RESPONSE TO REQUEST FOR ADDITIONAL INFORMATION

APR1400 Design Certification

RAI No.: 475-8596
SRP Section: 10.04.08 – Steam Generator Blowdown System
Application Section: 10.4.8
Date of RAI Issue: 05/04/2016

Question No. 10.04.08-6

Figure 2.7.1.8-1 Steam Generator Blowdown System

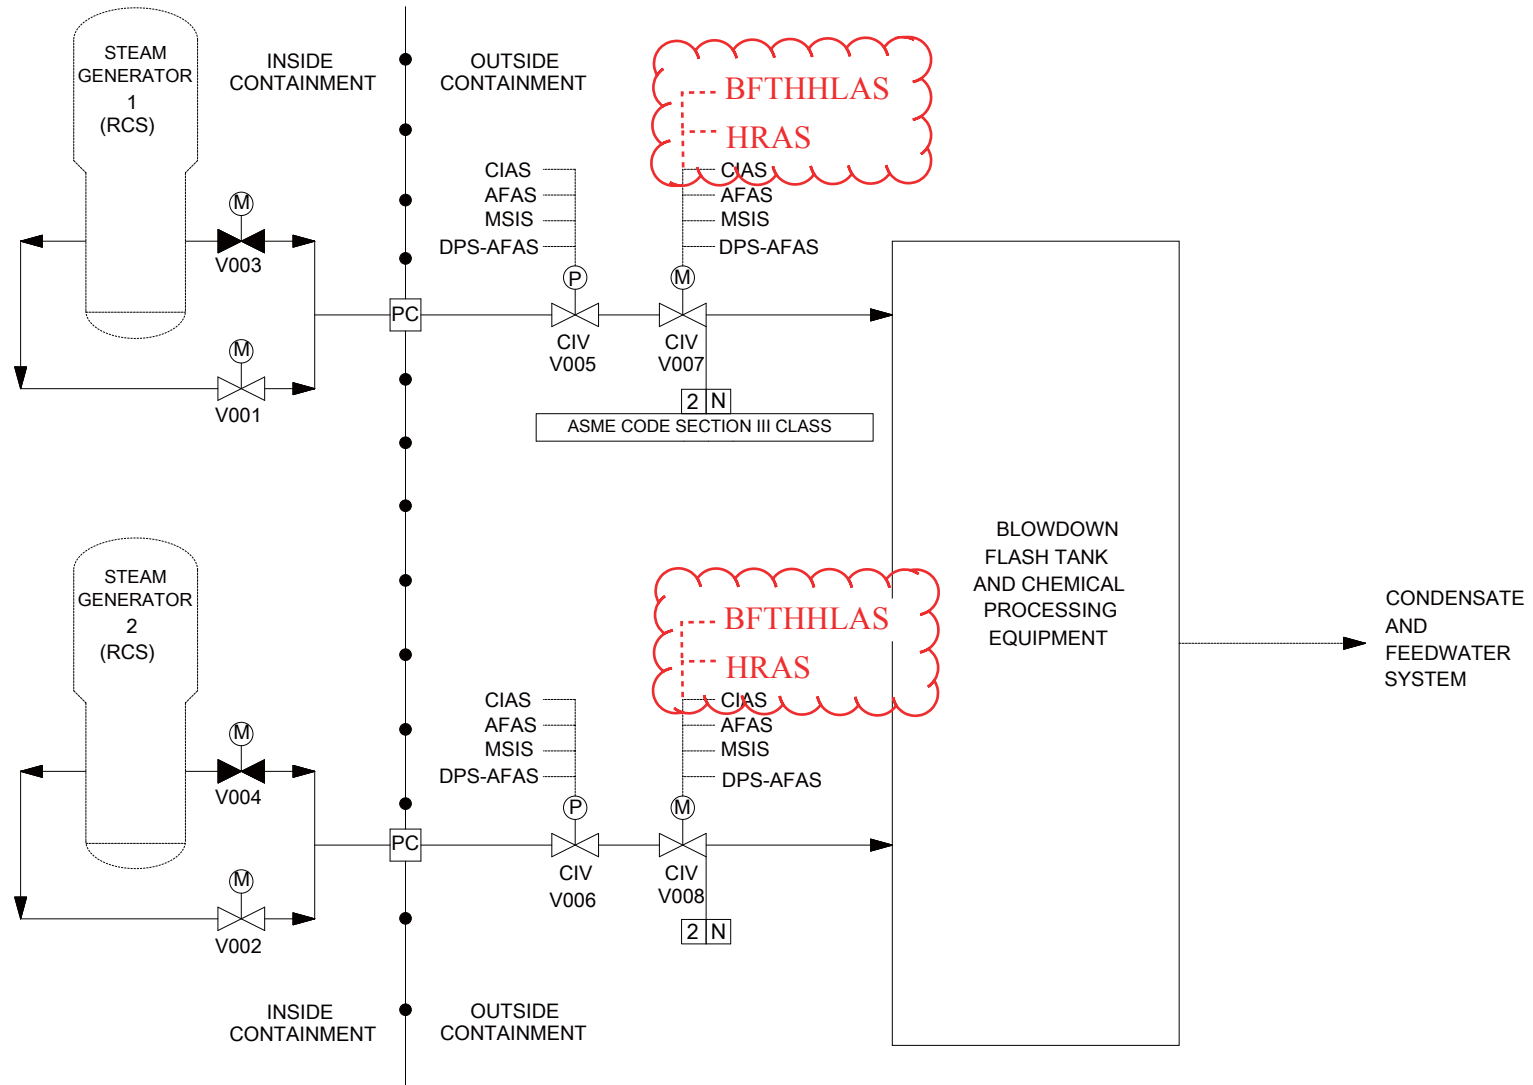
- a. The response proposes listing additional control signals in Tier 1 Table 2.7.1.8-1, but there is no corresponding change proposed for Tier 1 Figure 2.7.1.8-1. Since Figure 2.7.1.8-1 shows the control signals associated with containment isolation valves, provide your plans for revising Figure 2.7.1.8-1 or the basis for not revising it.
- b. The response indicates that Tier 2 Chapter 7 intentionally discusses the instrumentation and controls at a higher level and does not describe individual signals. The staff determined that for consistency and clarity, the signals that activate the containment isolation valves should be identified in Chapter 7, especially in the functional diagrams. Please discuss your plans to add this information to the FSAR.

- a. DCD Tier 1 Figure 2.7.1.8-1 and ACRONYM AND ABBREVIATION LIST will be revised to include the HRAS and the BFTHHLAS signals as indicated in the Attachment. And the signal lines in DCD Tier 2 Figure 10.4.8-1 will be revised to a dashed line as indicated in the Attachment.
- b. To activate the containment isolation valves (CIVs), following signals are used:
 1. ESFAS (e.g., SIAS, CSAS, CIAS, MSIS, and AFAS) and DPS (e.g., DPS-AFAS) signals

For example, steam generator blowdown system CIVs 005, 006, 007, and 008 in Figure 2.7.1.8-1 of DCD Tier 1 are actuated by the CIAS, AFAS, MSIS, and DPS-SIAS. However, those CIVs are not related with the SIAS and CSAS.
